MOO MOO CARWASH
2259 GRANVILLE STREET
GAHANNA, OHIO 43230

RE: Project 259 Granville St Final Development Plan

Re: Plan Review Comments, Review Response (dated April 4, 2018) for
Moo Moo Carwash **Final Development Plans ~ FDP-XXX**
259 Granville Street, Gahanna, Ohio

PLANNING AND DEVELOPMENT STAFF REPORT

LANDSCAPING PLAN 1" = 20'

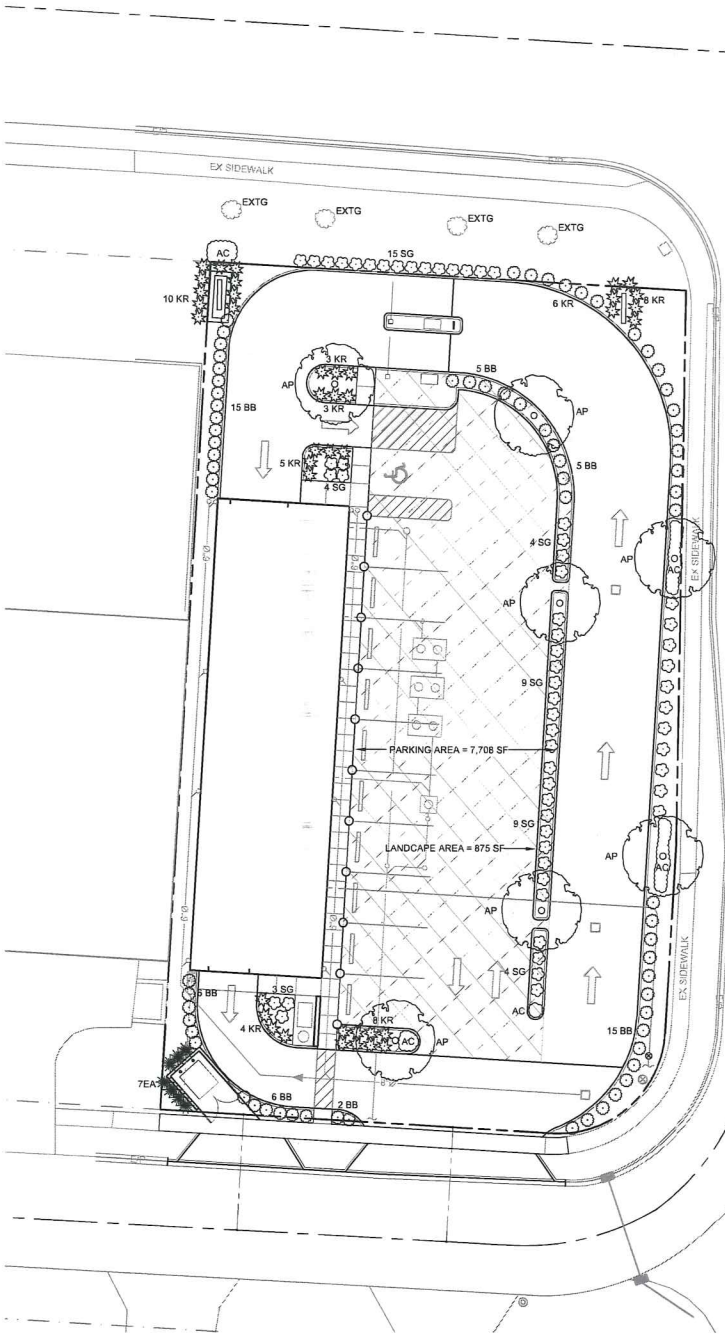
12. The FDP application and CH 1163.08 requires the square footage of the parking area in order to calculate the required amount of landscaping. Please revise sheet 2 (landscape/lighting) to include the square footage of the parking area. Please be aware that CH 1163.08(c) requires the amount of interior landscaping be 5% of the total parking lot pavement. One tree per 100 square feet of landscaping is required.

12. The FDP application and CH 1163.08 requires the square footage of the parking area in order to calculate the required amount of landscaping. Please revise sheet 2 (landscape/lighting) to include the square footage of the parking area. Please be aware that CH 1163.08(c) requires the amount of interior landscaping be 5% of the total parking lot pavement. One tree per 100 square feet of landscaping is required.

Landscaping plan has been revised to show compliance. Also note landscape data table for compliance requirements.

2 WEST ELEVATION

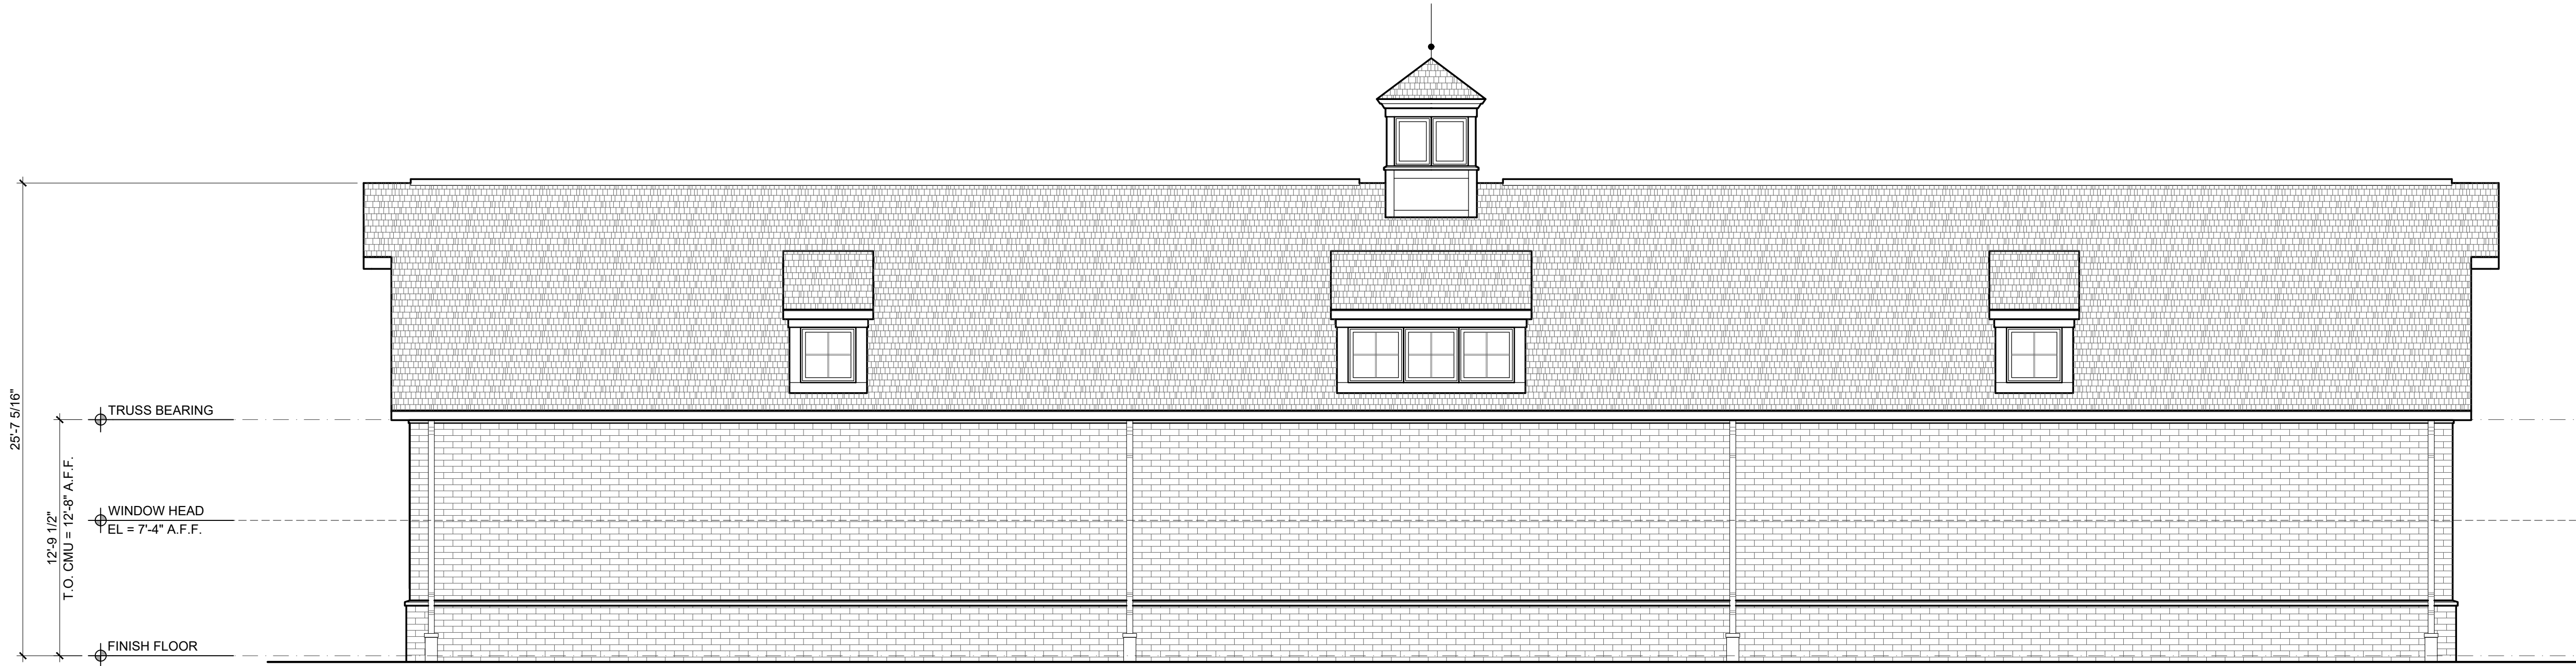
1. The west wall of the building will be required to have a fire rating - depending on the fire separation distance to the west property line, with limitations on openings along the west property line.
(*Building Elevations*)

1. The west wall of the building will be required to have a fire rating - depending on the fire separation distance to the west property line, with limitations on openings along the west property line.

There is one comment outstanding from Planning and Development staff regarding the building elevations. Staff recommends additional architectural elements be added to the west façade. This façade does not contain as much fenestration as the east façade. However, the west façade is partially obstructed by the shopping plaza immediately adjacent to this site.

The proposed car wash is 5'-0" away from the West property line. The Ohio Building Code Table 602 (attached) states that for a "B" Use Group of Type VB construction that the distance would need to be less than 5'-0" to the property line to be required to be fire rated.

The Ohio Building Code's definition of "Fire Separation Distance" is also attached. Fire Separation Distance is measured from a property line, a building also on your lot, or the centerline of a street.

Our interpretation is that the west wall of the building will not require fire rating although the roof overhang of the west side is less than 5'-0" to the property line and will require fire rating. It is the intent to slide the dormers back 6" on the roof to avoid the need for fire rating the dormer roofs as well.
